**STAFF REPORT**  
**COMMUNITY DEVELOPMENT DEPARTMENT**

DATE: 3/17/2026  
TO: City Council  
FROM: Sonya Allen, Associate Planner  
208-884-5533  
[sallen@meridiancity.org](mailto:sallen@meridiancity.org)  
SUBJECT: FP-2025-0013  
Burnside Ridge Estates No. 1

Final plat consisting of 52 buildable lots and 15 common/other lots on 26.26 acres of land in the R-4 and R-8 zoning districts for the first phase of Burnside Ridge Subdivision.

Note: This revised Phasing Plan was approved by Staff on 10/2/25

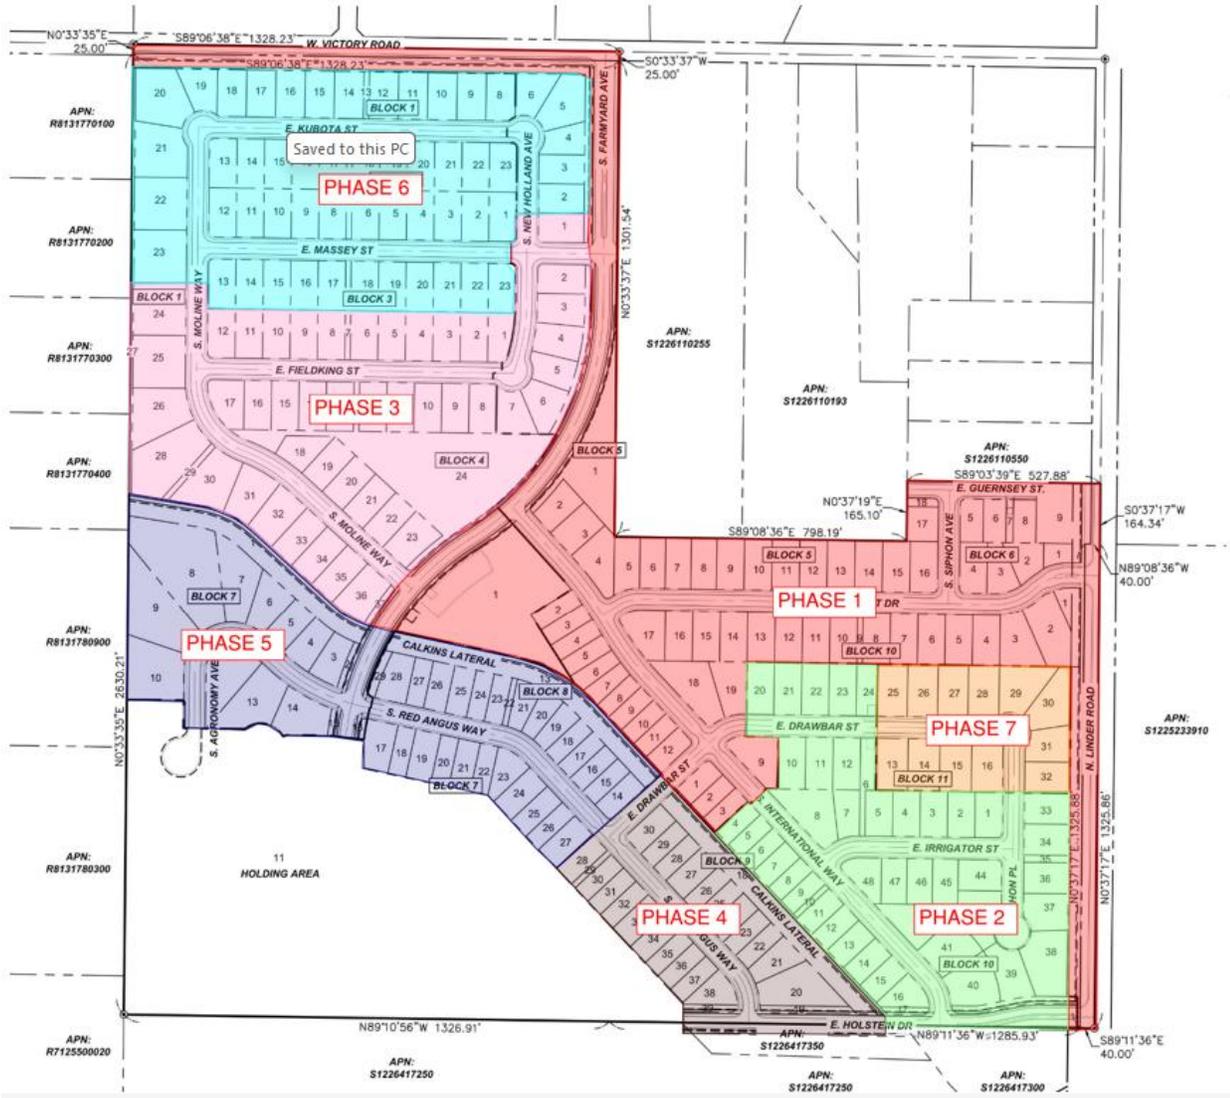
Staff has reviewed the proposed final plat for substantial compliance with the preliminary plat (H-2023-0055) as required by UDC 11-6B-3C.2. The proposed final plat depicts two (2) fewer building lots and a greater amount of common open space (201,500 s.f. vs. 288,500 s.f.) in the same area shown on the approved preliminary plat and includes some modifications as outlined below, including changes to amenities. The configuration of this phase complies with the updated phasing plan approved by Staff on 10/2/2025, included below in Section V.A.

SHEET 4 OF 6

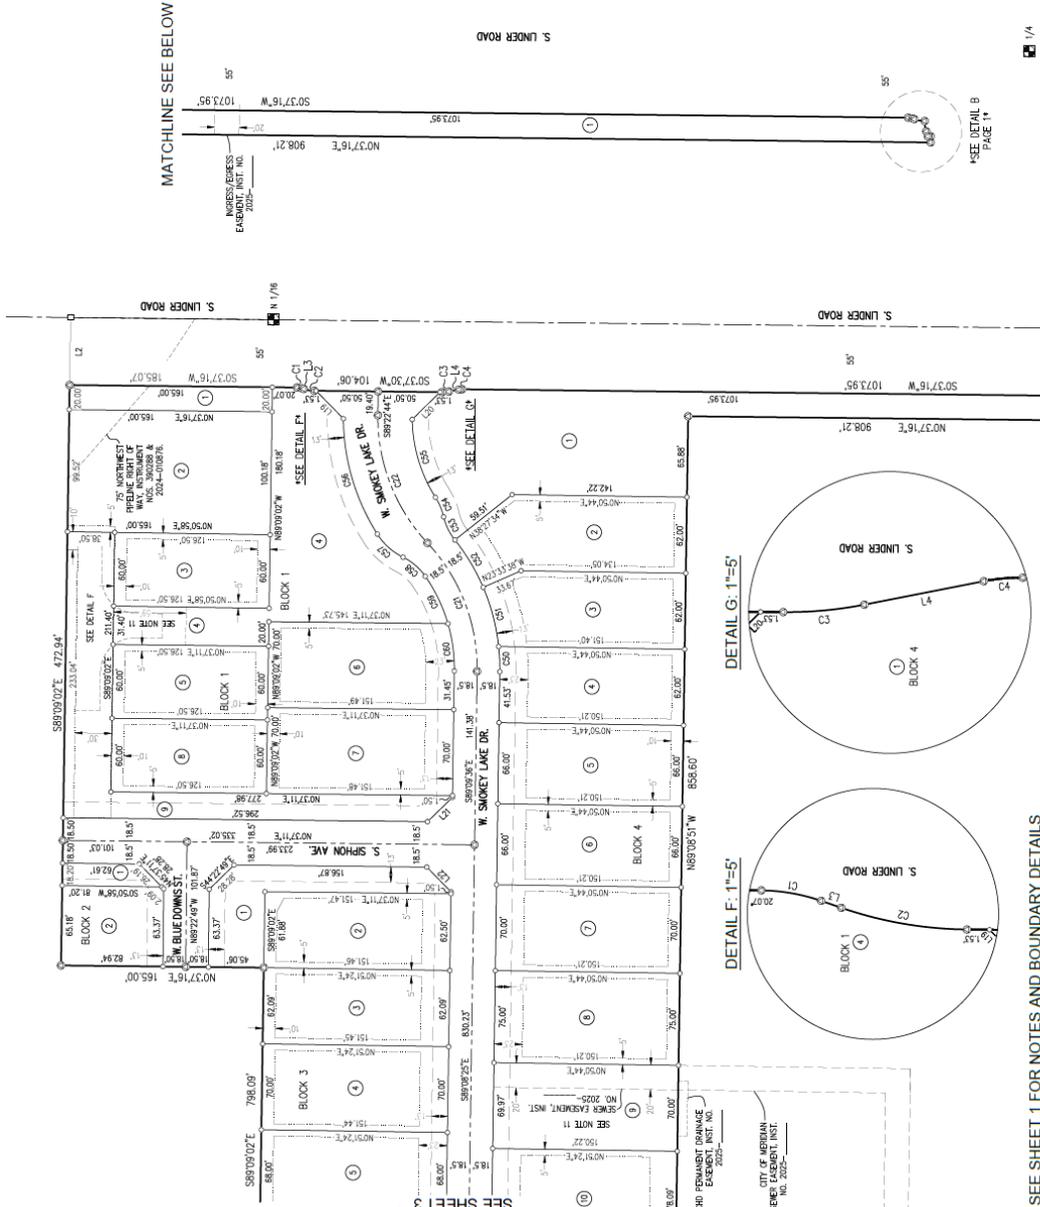
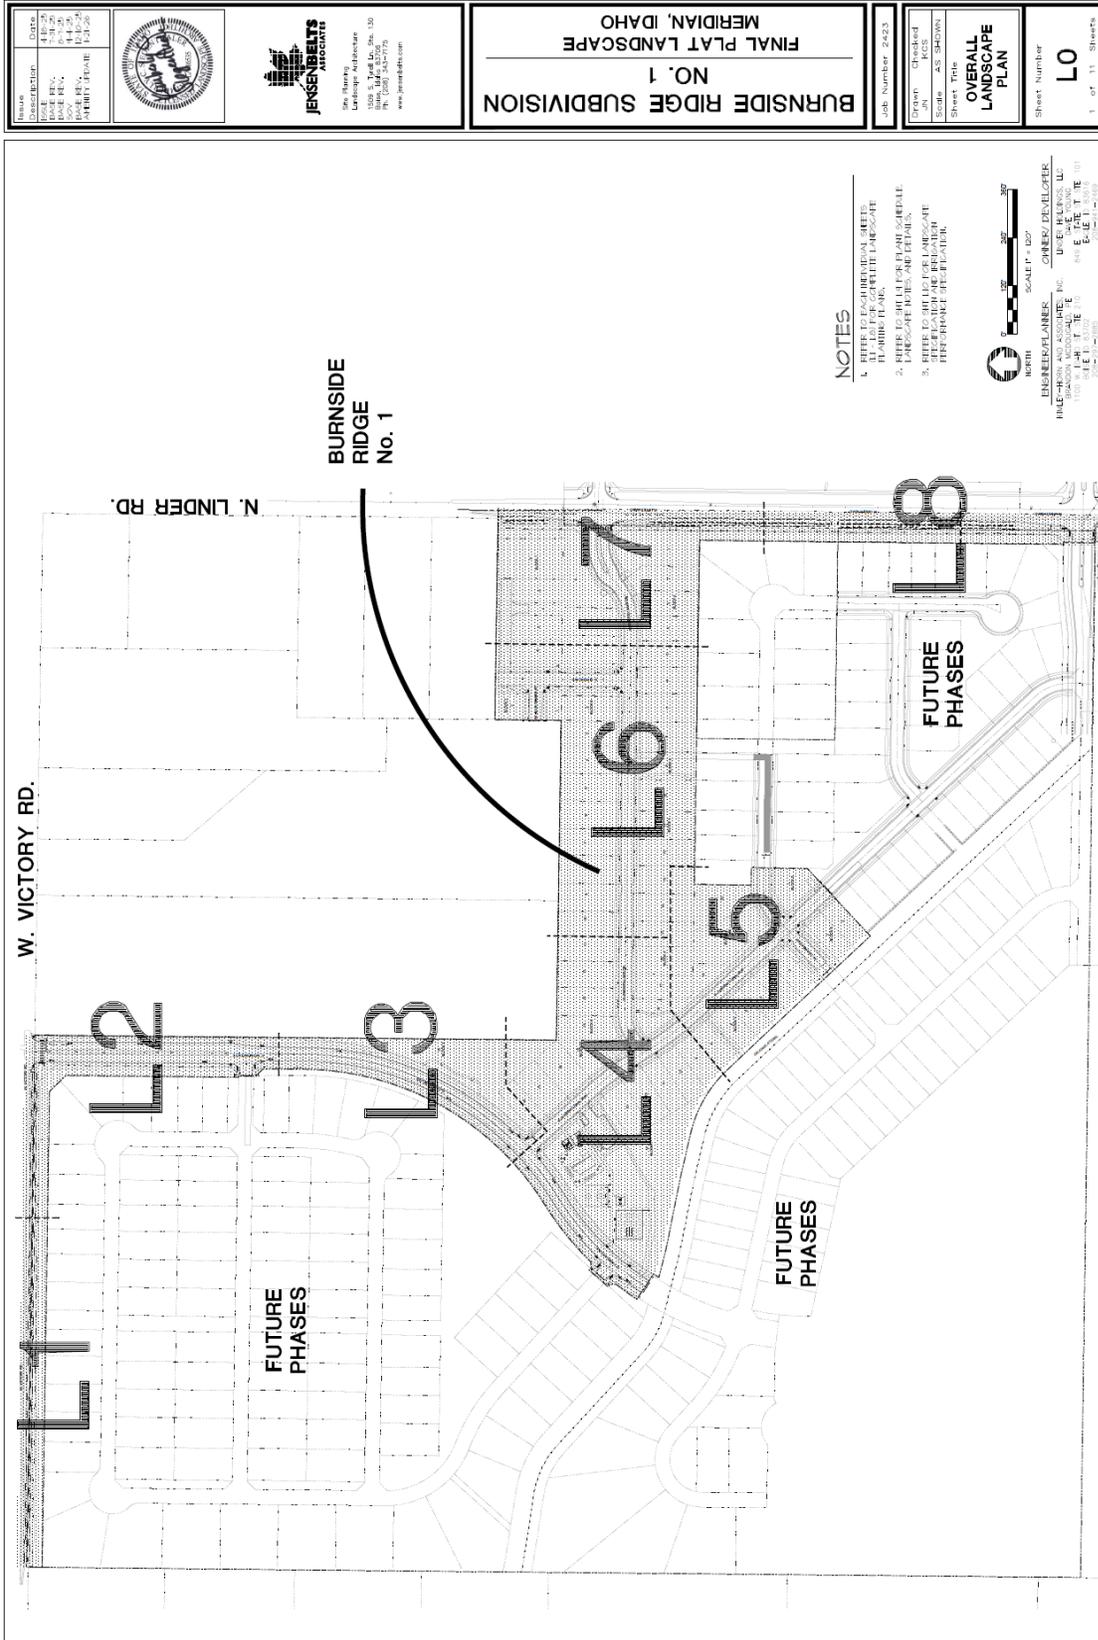
3. Prior to submittal for the City Engineer's signature, have the Certificate of Owners and the accompanying acknowledgement signed and notarized.
4. The final plat prepared by Land Solutions Land Surveying and Consulting, stamped on 8/21/25 by Clinton W. Hansen, included in Exhibit B shall be revised as follows:

- a. Note #10: Include the recorded instrument number of the development agreement (i.e. #2024-063338).
  - b. Note #12: Include the recorded instrument number of the ACHD temporary license agreement.

- c. Note #16: Include the recorded instrument of the ACHD development agreement.
  - d. Legend: Include the recorded instrument number of the ACHD permanent easement line.

- e. Include the recorded instrument number of the ACHD temporary easement graphically depicted on Sheets 3 and 4.
  - f. Include the recorded instrument number of the City of Meridian sewer easement graphically depicted on Sheets 3 and 4.

- g. Include the recorded instrument number of the ingress/egress easement graphically depicted on Sheet 4.
  - h. The final construction drawings shall depict a 10-foot-wide detached sidewalk along the northern portion of the east side of S. Farmyard Way, a collector street, in accord with preliminary plat condition #2g, unless otherwise approved through a development agreement modification. *If a modification to the DA isn't approved to reduce the width of the sidewalk to 5 feet, alternative compliance may be requested to provide an attached 10-foot-wide sidewalk.*

- i. Extend S. Siphon Ave. as a stub street to the north property boundary for future extension along with the sidewalks on either side (there appears to be a gap).

- j. Break up Lot 9, Block 1 into two (2) lots – one for the street buffer and one for the common driveway.
  - k. Depict traffic calming measures on the construction drawings for W. Smokey Lake Dr. (shown as E. Pivot Dr. on the preliminary plat) in the form of bulb-outs, chokers, stamped concrete, etc. due to the long block face; work with ACHD to determine an appropriate means of traffic calming in accord with preliminary plat condition #2e.

Sheet Number: **L0**  
 1 of 11 Sheets

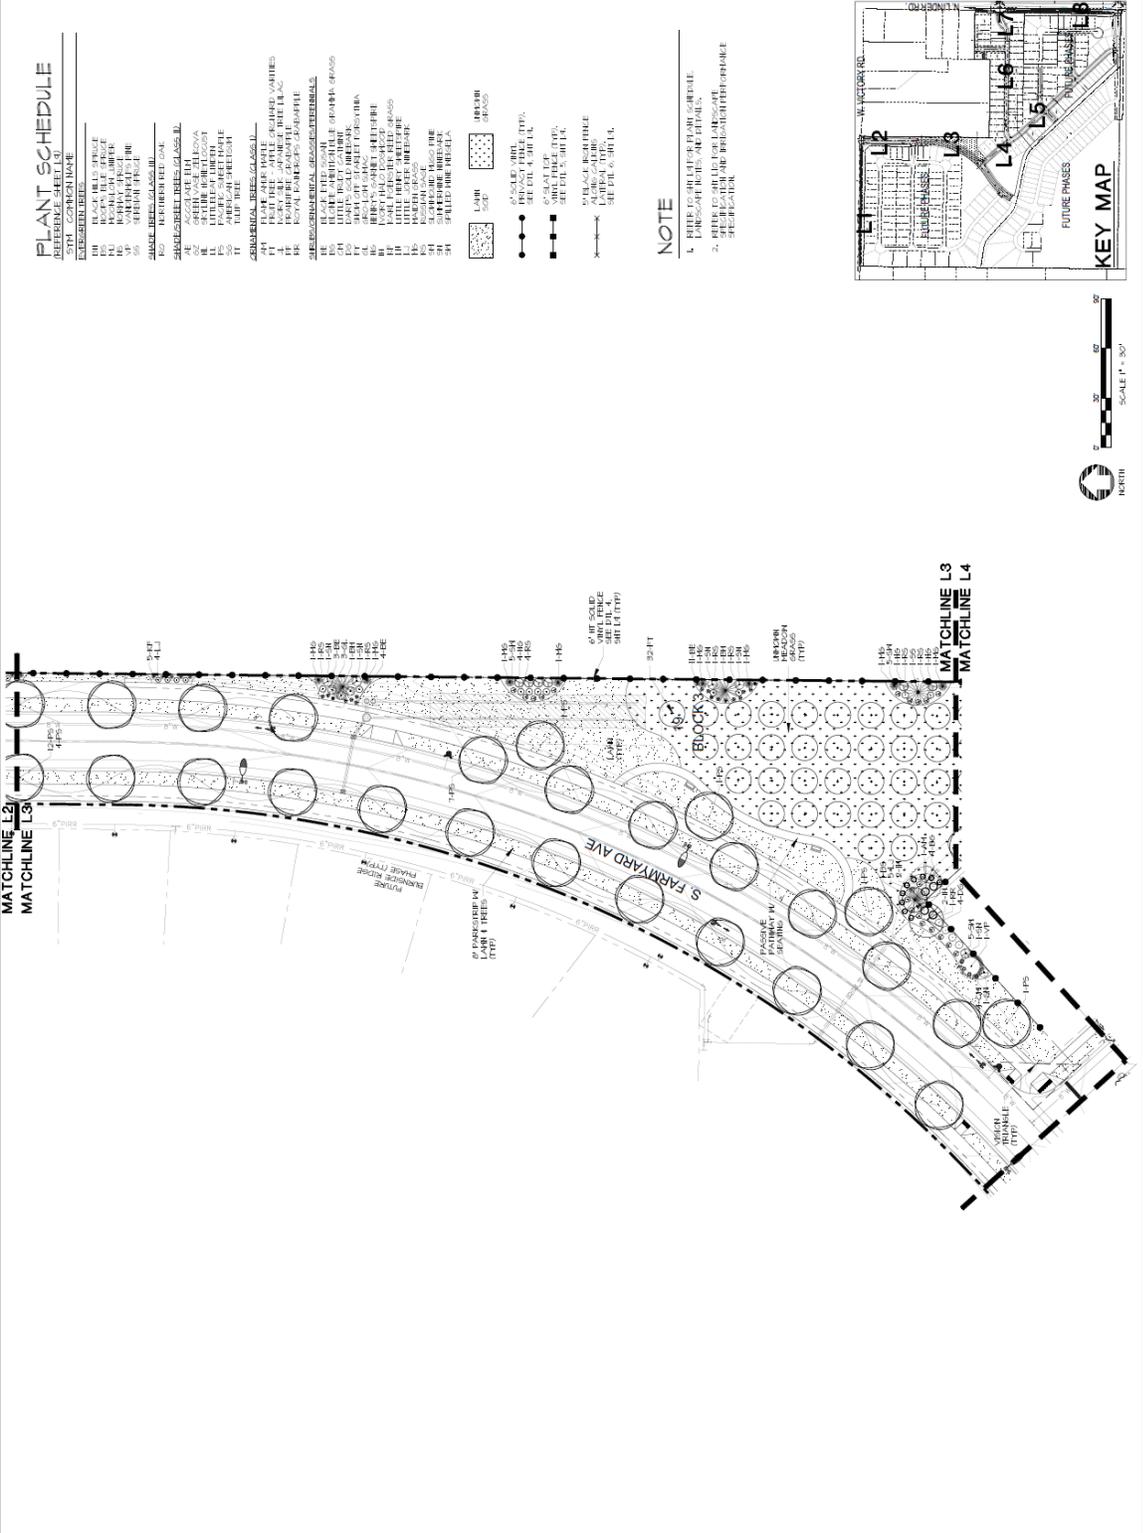
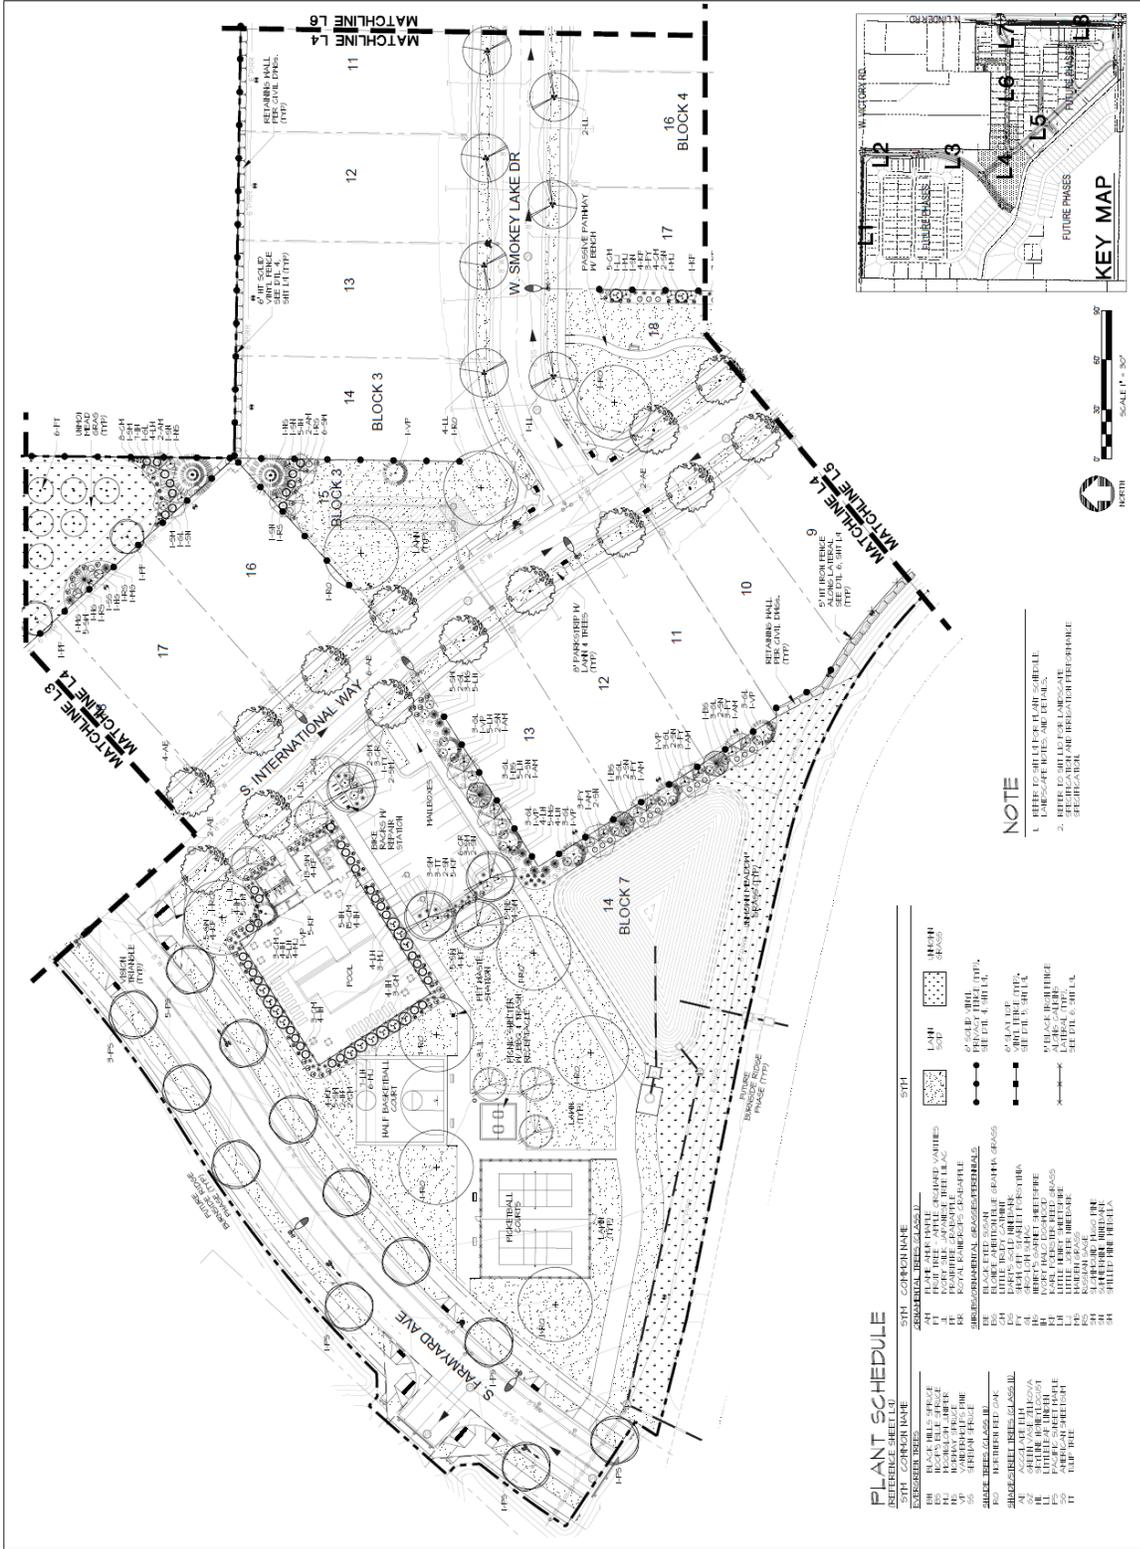
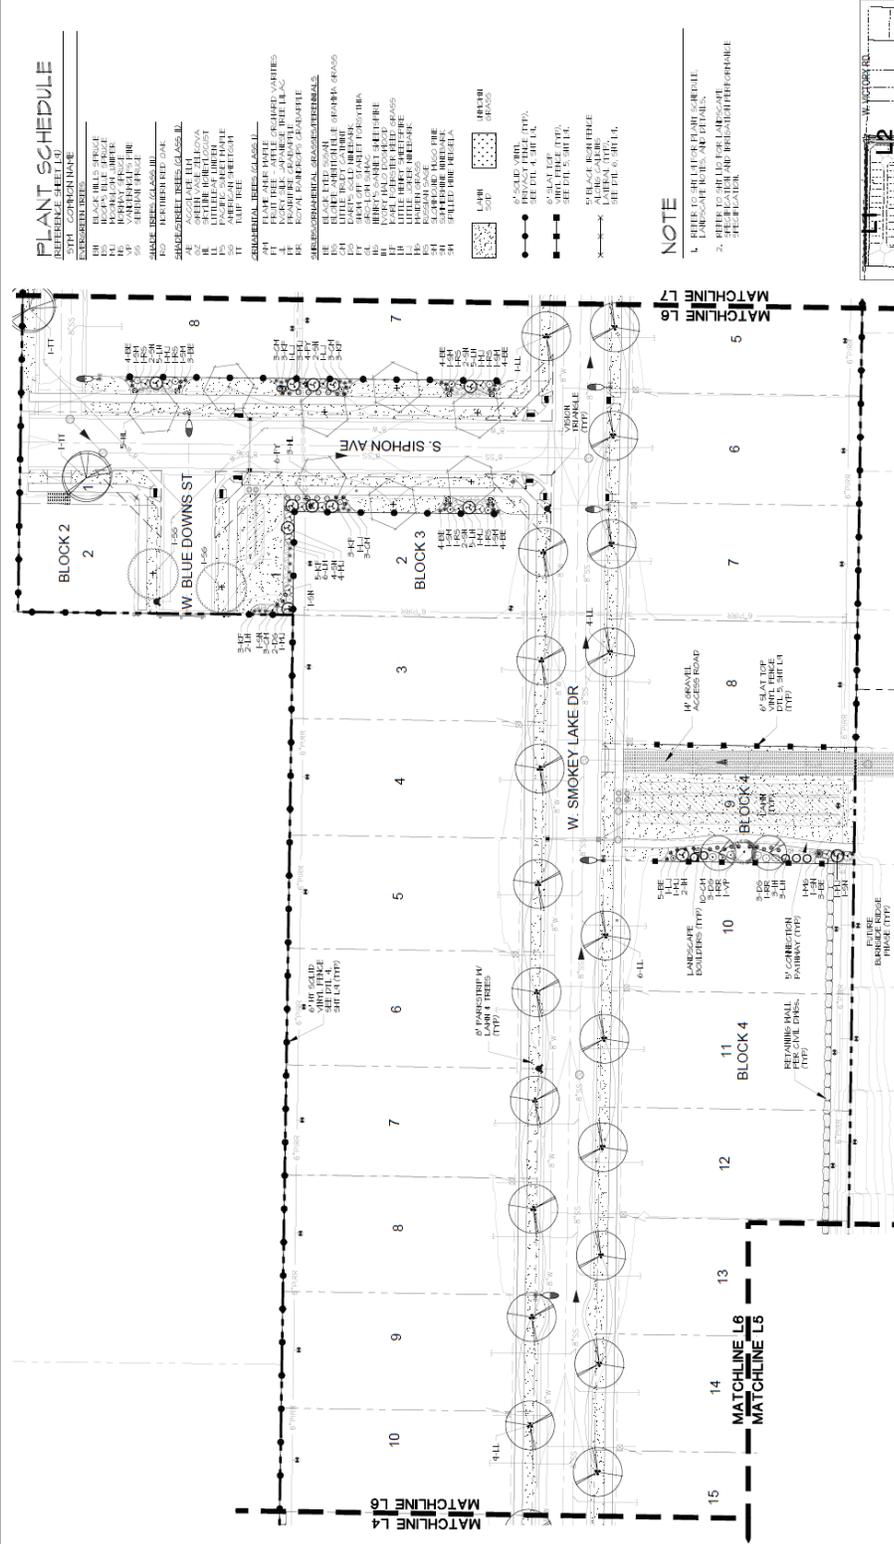
5. The landscape plan prepared by Jensen Belts Assoc., dated 8/7/25 included in Exhibit C, shall be revised as follows:
  - a. Depict a 10-foot-wide detached sidewalk along the east side of the northern portion of S. Farmyard Way, a collector street, in accord with preliminary plat condition #2g, unless otherwise approved through a development agreement modification. *If a modification to the DA isn't approved to reduce the width of the sidewalk to 5 feet, alternative compliance may be requested to provide an attached 10-foot-wide sidewalk.*

- b. Where the unimproved street right-of-way is ten (10) feet or greater from the edge of pavement to edge of sidewalk or property line along Linder Rd., a ten-foot compacted shoulder shall be depicted meeting the construction standards of the transportation authority with landscaping (i.e. lawn or other vegetative ground cover) in the remaining area, per UDC 11-3B-7C.5. *Landscaping improvements within the right-of-way shall require a license agreement between the property owner and the transportation authority.*

- c. Depict the future curb location as anticipated by ACHD along W. Victory Rd. and S. Linder Rd.; depict a minimum 25-foot-wide street buffer, measured from the ultimate curb location, along both streets.

- d. Depict landscaping with a *variety* of materials, including shrubs and vegetative groundcover, within the required street buffer along S. Farmyard Ave., a collector street, in accord with the standards listed in UDC 11-3B-7C.3; include calculations that demonstrate compliance in the Landscape Calculations table on Sheet L9.

- e. The street buffers along S. Linder Rd., W. Victory Rd., and S. Farmyard Ave. shall include enhanced landscaping as set forth in 11-3B-7C.3f with enhanced amenities with social interaction characteristics and enhanced context with the surroundings in accord with the standards listed in UDC 11-3G-3B.3. Include call-outs for what specific enhanced landscaping and amenities are proposed to meet these standards.

- f. Depict landscaping with a mix of materials along each side of all pathways, in accord with the standards listed in UDC 11-3B-12C; include calculations that demonstrate compliance in the Landscape Calculations table.

- g. Extend S. Siphon Ave. as a stub street to the north property boundary for future extension along with the sidewalks on either side (there appears to be a gap).

- h. The picnic area shall include tables, benches, landscaping, and a structure for shade in accord with UDC 11-3G-4C.5; depict accordingly.
  - i. Depict a standard bus stop (size small) with a 10' x 10' concrete pad along N. Linder Rd. just south of W. Smokey Lake Dr. (depicted as E. Pivot Dr. on the preliminary plat) as requested by Valley Regional Transit (VRT). The purpose of the pad is to provide an ADA compliance boarding/alighting area. The pad will allow VRT to schedule a stop there as part of future route planning and place signage and a bench onsite.
